Rother Valley Railway  
Non-Motorised User (NMU) Audit Report  
July 2013

Rother Valley Railway  
Non-Motorised User (NMU) Audit Report

July 2013

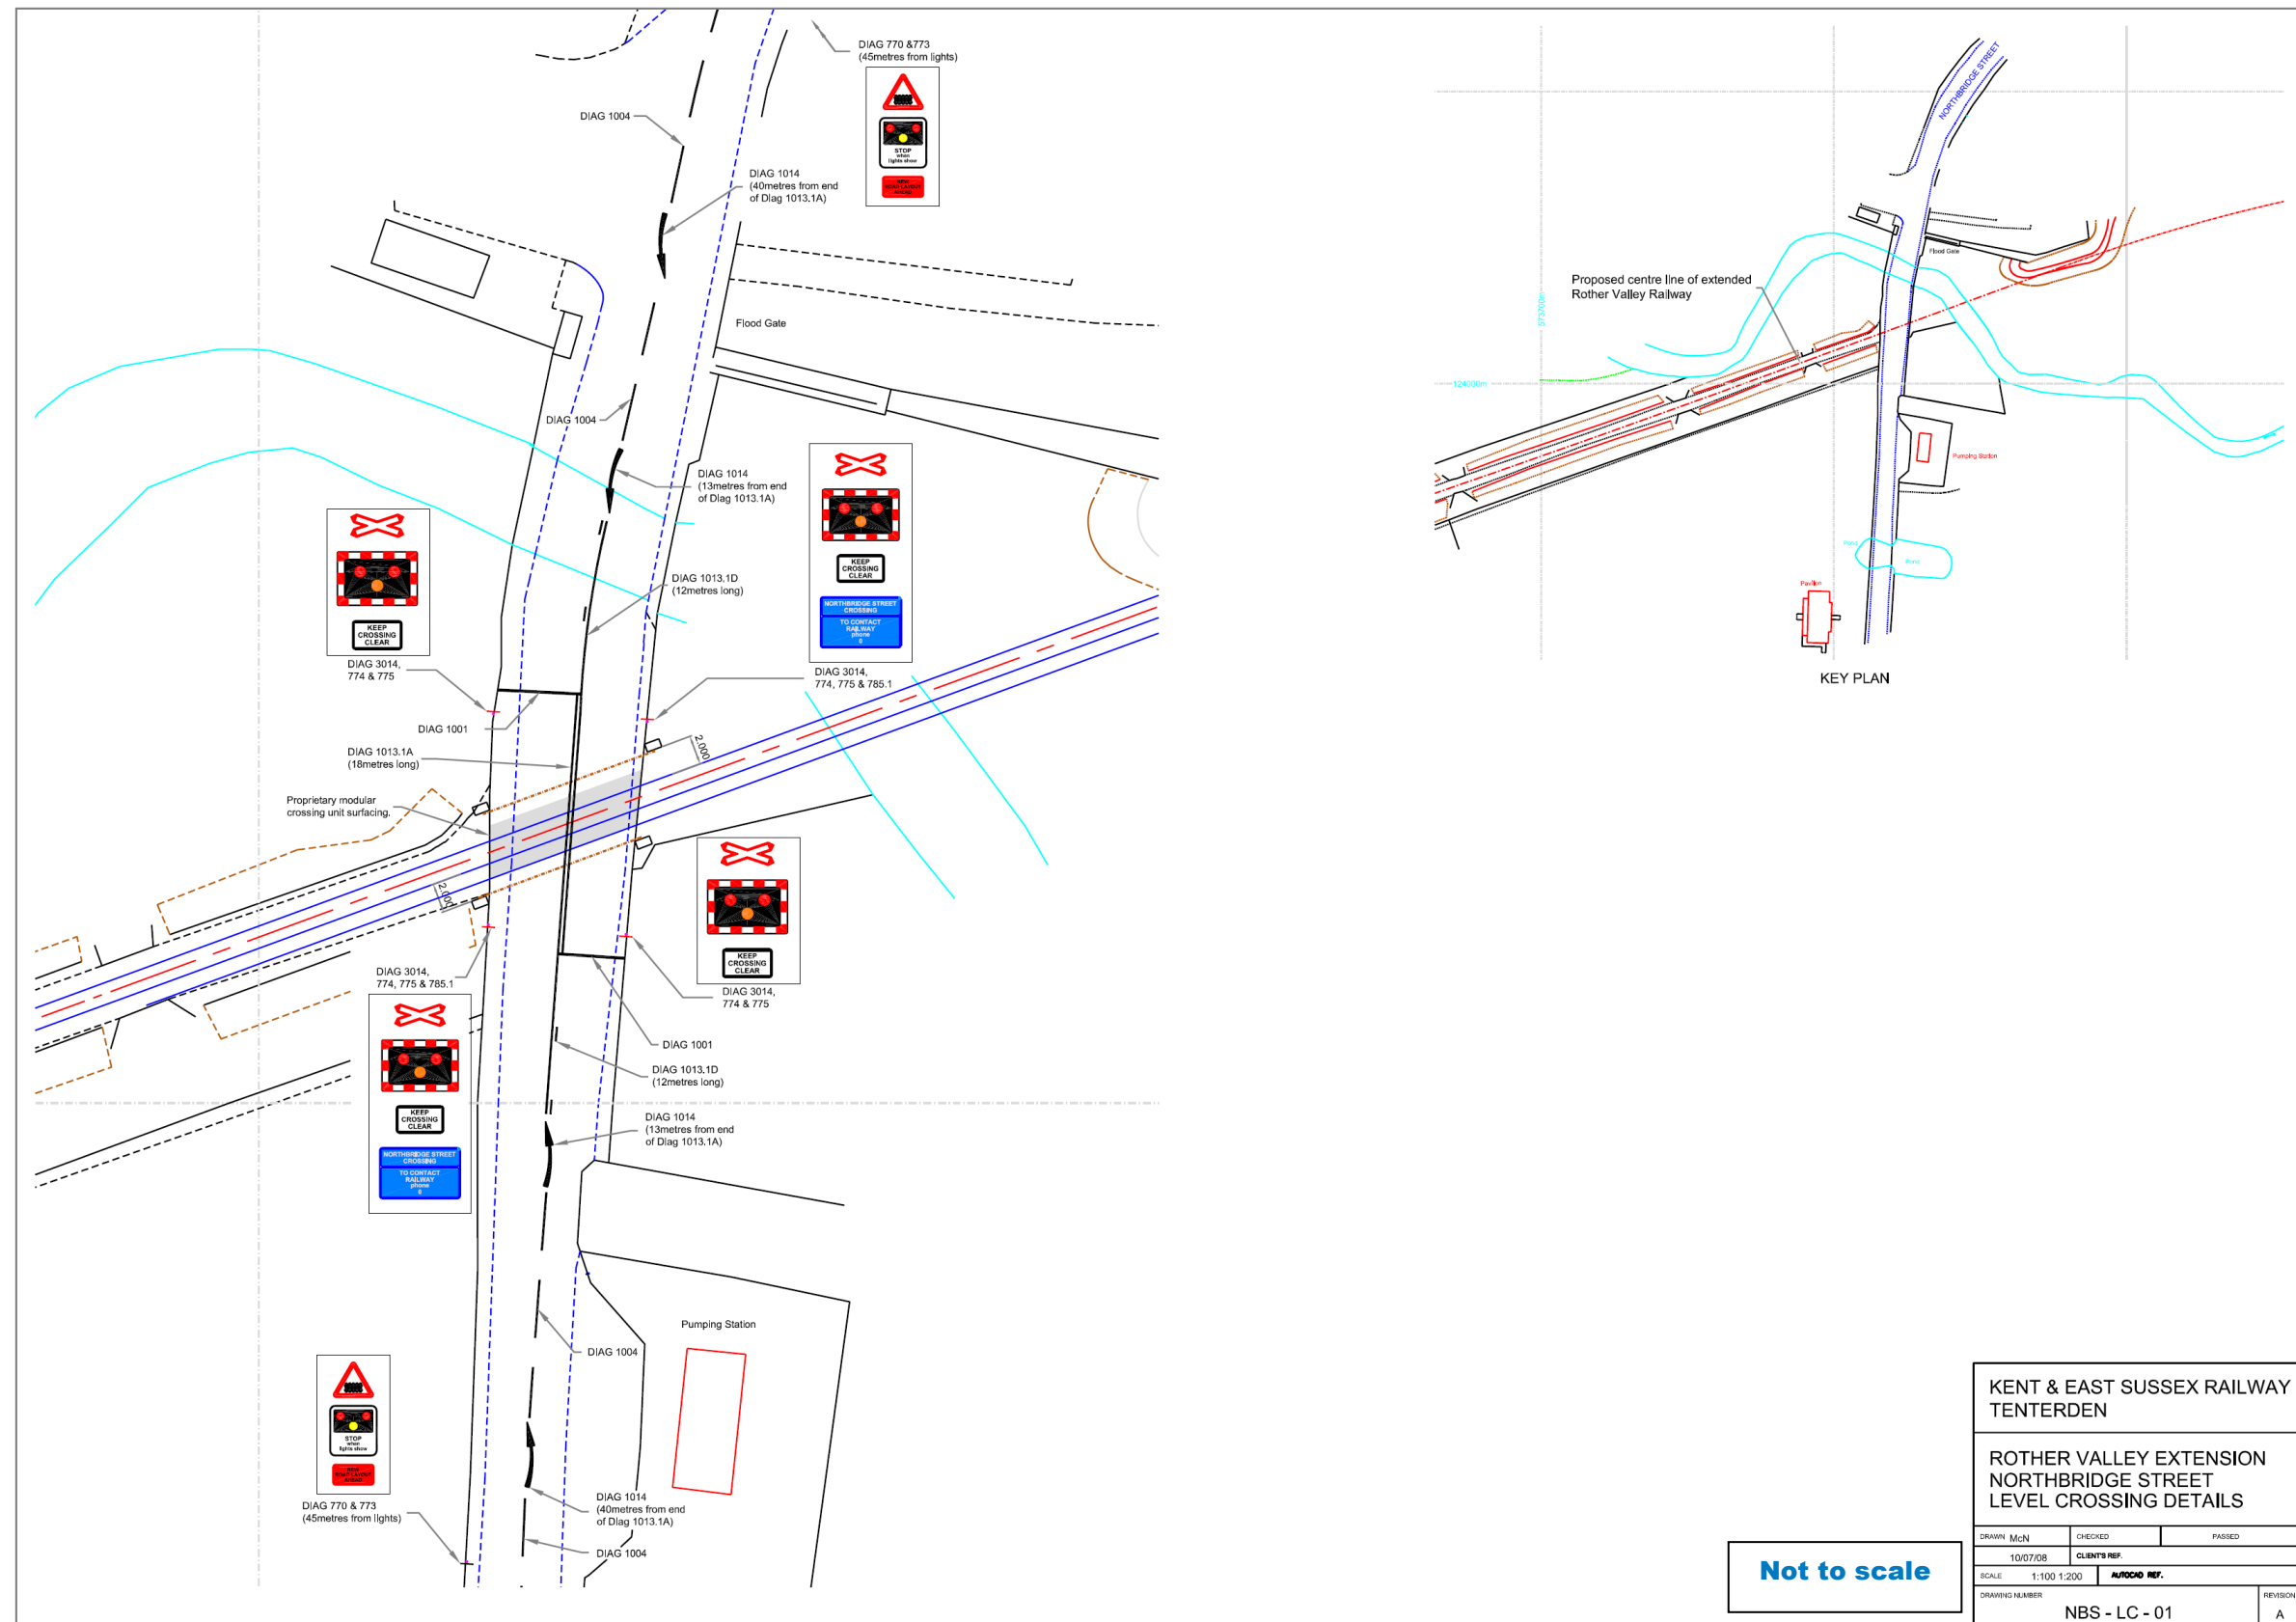
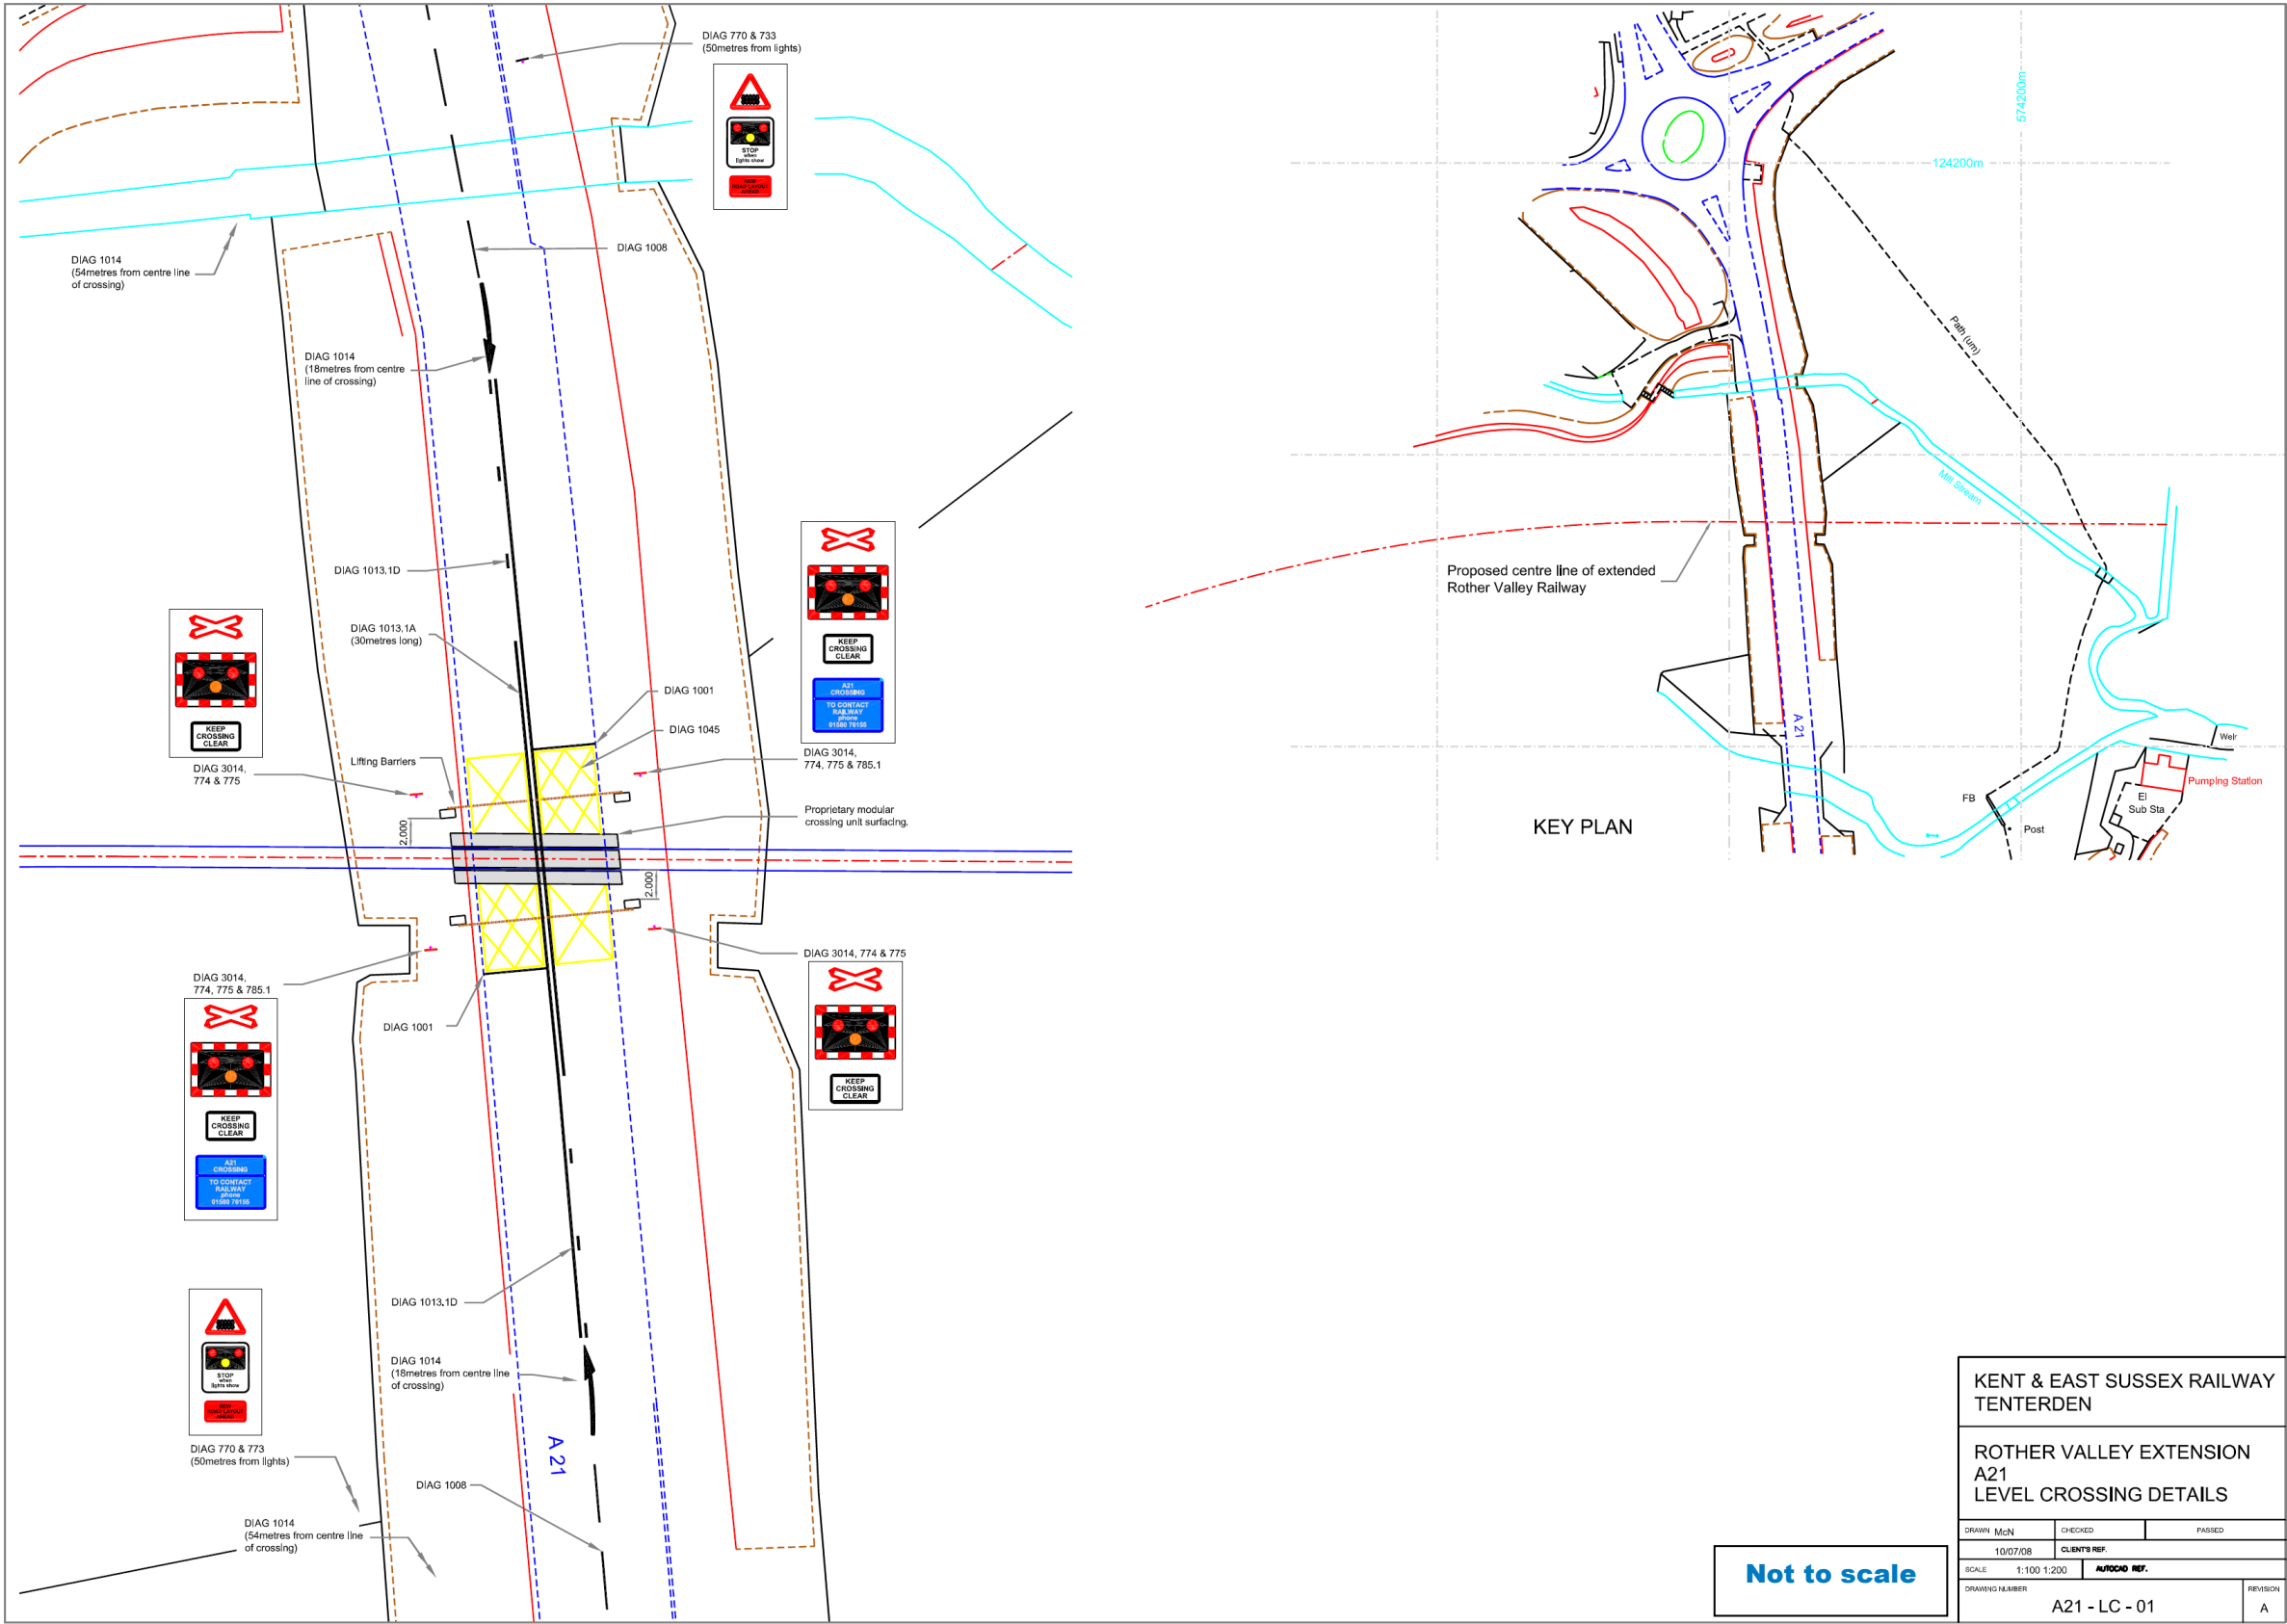
The drawings, prepared by Rother Valley Railway, show the proposed layout for each rail level crossing. These feature a full (carriageway) width barrier with the intention to prevent vehicular traffic and NMUs incurring into the level crossing.

It is unclear whether the barriers and fencing will completely prevent the risk of NMUs crossing the rail line when in operation. Any gaps between the crossing gates and the boundary fence may allow NMUs to bypass the barrier.

The barriers are being incorporated into the railway corridor fence line, preventing NMUs access across the railway when the gate is in operation.

No supplementary NMU access across the railway would be provided at the level crossing.
